DESIGN STANDARDS STAFF REPORT

Board: Building and Site Design Committee

File No(s): BSD 022-16

1. **Building and Site Design Approval** for architectural plans related to construction of a new 6,988 sq. ft. convenience store [Jacksons] per application and plans...(hereinafter the alternatively the "Building", "Structure", or "Convenience Store", etc.)

NORTH ELEVATION

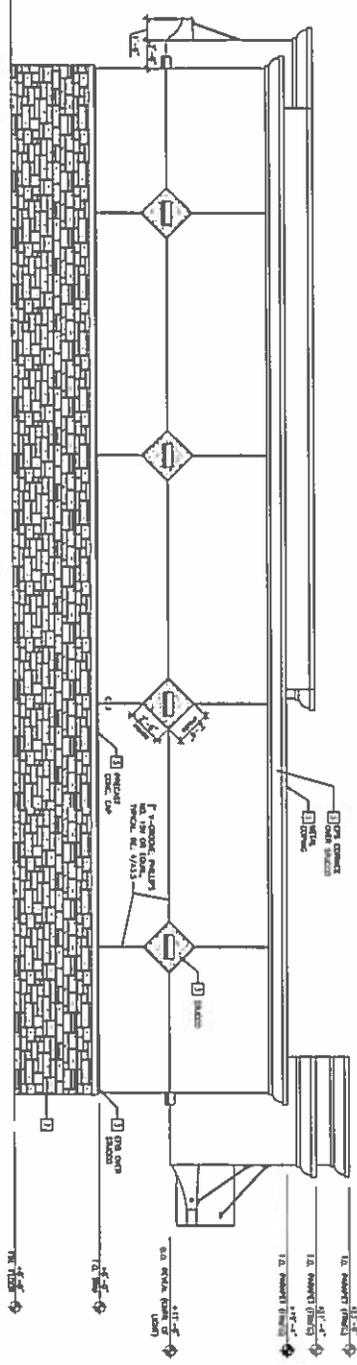
- **North Wall:**

As a modern or contemporary building style, the traditional architectural features proposed by the Building are typical of that kind of motif. The north wall is the least embellished façade of the Building. Forty percent of the approximated wall area is 518.40 sq. ft. There is some 531 (wainscot, cornice cap and decorative wall light packs) sq. ft. of architectural elements on the wall. Thus, the north side has ~41% percent compliance and is therefore deemed to be code compliant.

WEST ELEVATION

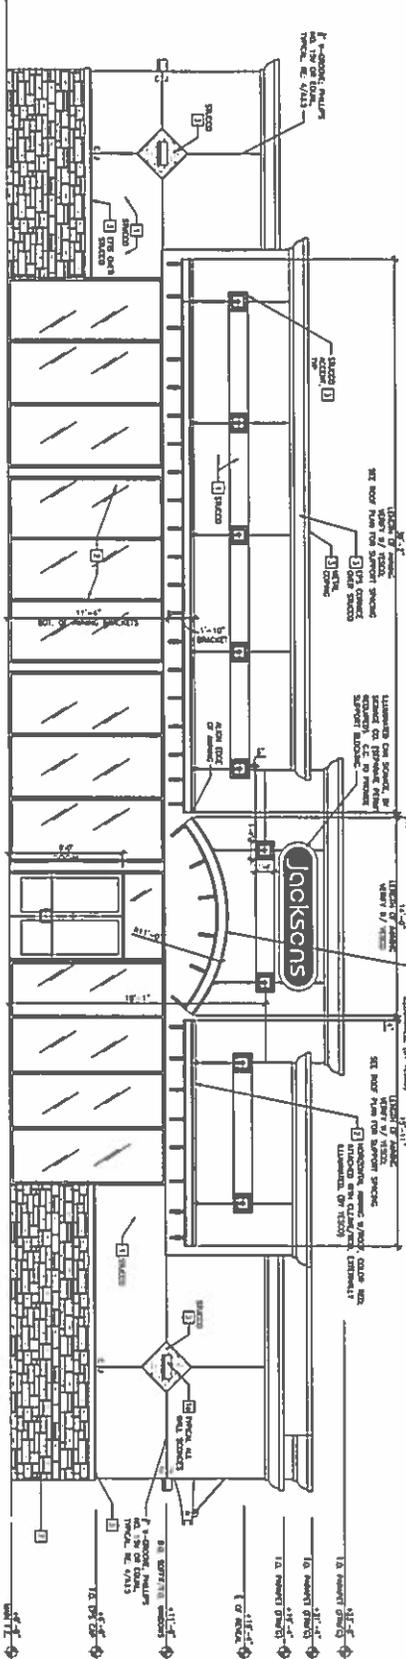
- **West Wall:**

As a modern or contemporary building style, the traditional architectural features proposed by the Building are typical of that kind of motif. Forty percent of the approximated wall area is 518.40 sq. ft. The percentage of compliance is found to exceed 40% by consideration of the fenestration, cornice work, cultured stone veneer wainscot, accent awning and, possibly the over-built, popped out store storefront parapet assembly.

The floor plan notes that a lobby and retail area will be provided (along with public restrooms) off the west side of the Structure, accessible by man doors from the east, west and south of the Building. Given the raised parapet and eyebrow awning section, as well as signage display, it is obvious that the west side of the building will contain the main entrance.

The intended primary façade(s) [front and/or a side or rear wall(s) that faces a street] for the Building under review is the west side, with the south side also having street frontage view. Both sides have

EAST ELEVATION

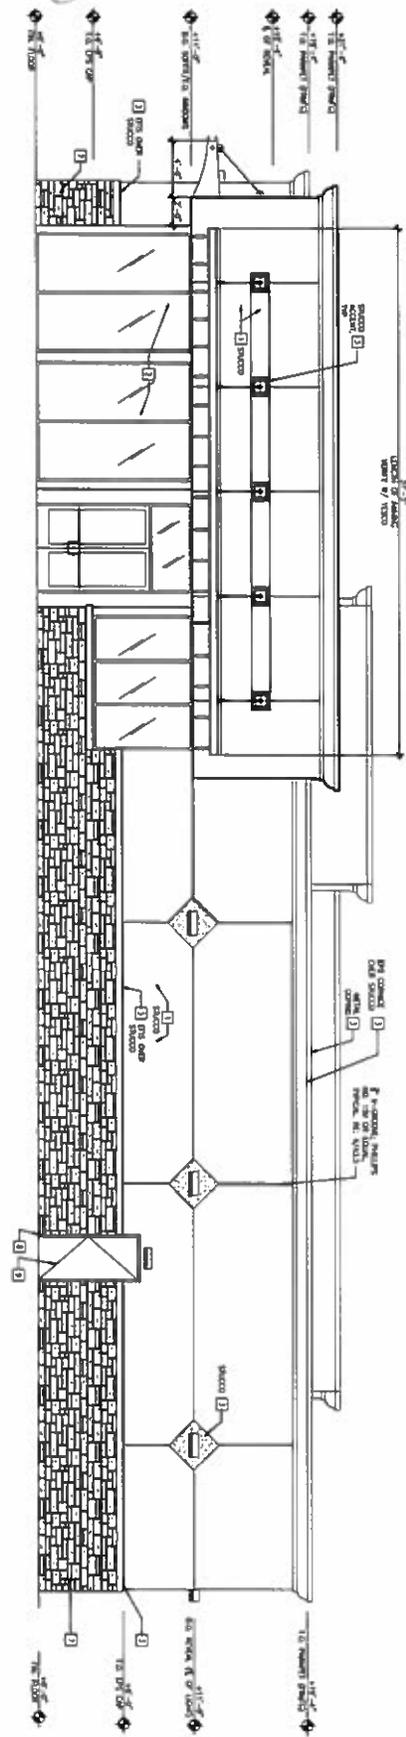
- **East Wall:**

As a modern or contemporary building style, the traditional architectural features proposed by the Building are typical of that kind of motif. Forty percent of the approximated wall area is 518.40 sq. ft. The percentage of compliance is found to exceed 40% by consideration of the fenestration, cornice work, cultured stone veneer wainscot, accent awning and, possibly the over-built, popped out store storefront parapet assembly.

SOUTH ELEVATION

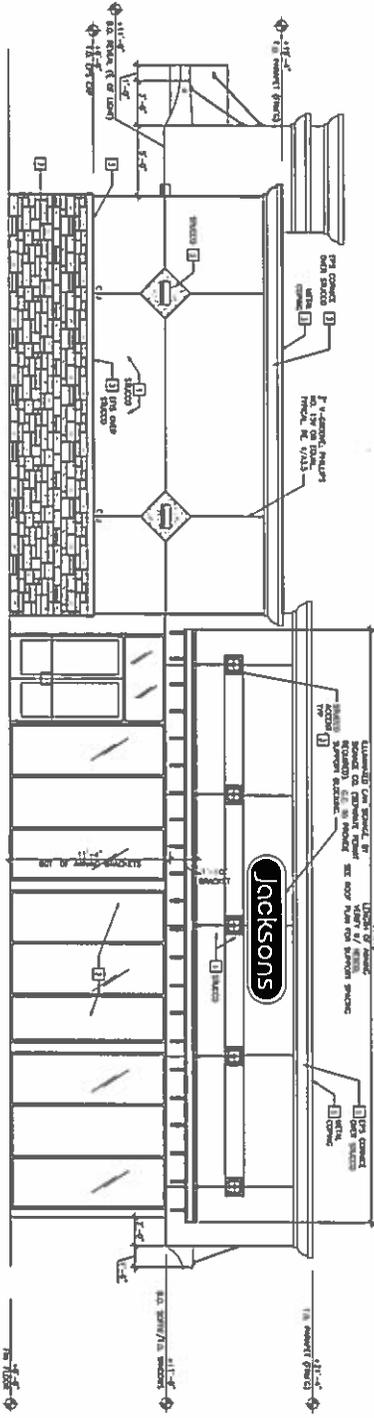
- **South Wall:**

As a modern or contemporary building style, the traditional architectural features proposed by the Building are typical of that kind of motif. Forty percent of the approximated wall area is 518.40 sq. ft. The percentage of compliance is found to exceed 40% by consideration of the fenestration, cornice work, cultured stone veneer wainscot, accent awning and, possibly the over-built, popped out store storefront parapet assembly.

over 25% glazing as part of their wall area composition. The south side which has less still has almost 50% of its wall surface (not roof system) given over to fenestration.

SITE PLAN
SCALE: 1" = 30'-0"

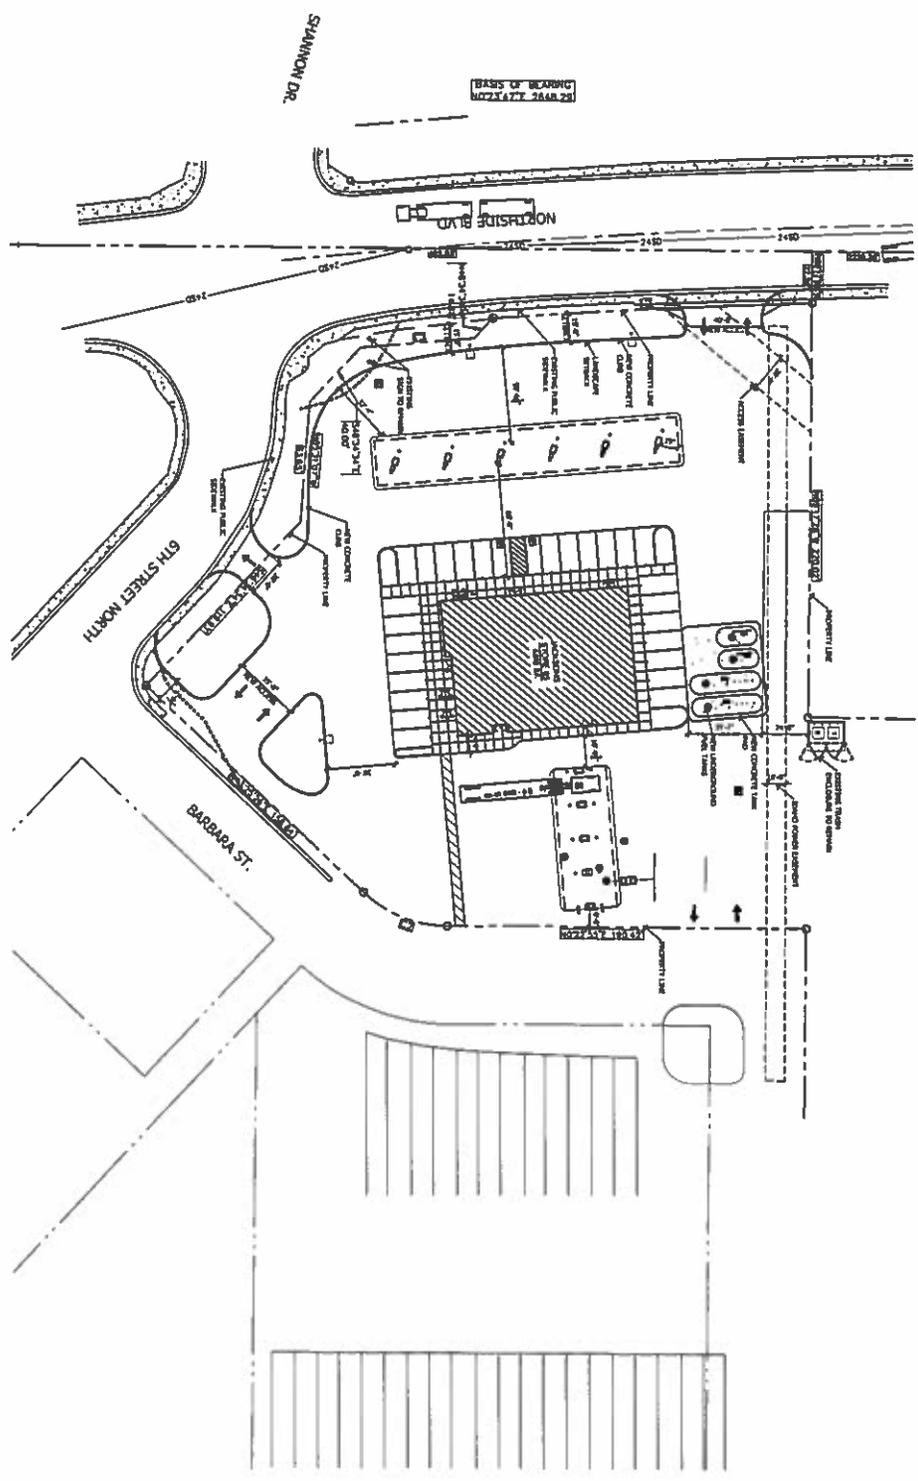
Pre-existing -- shown at the north/northeast far side of the Property in an enclosed area. Details regarding the proposed enclosure were not provided.

A pedestrian plaza over 40 sq. ft. in size is not required for this Project as the proposed Building is under 25,000 sq. ft. in area (6,988). Notwithstanding, plans call for an outside sidewalk system

around the entire Building, with a sit down patio area at the southeast corner of the Structure – see attached site and/or landscape plan(s).
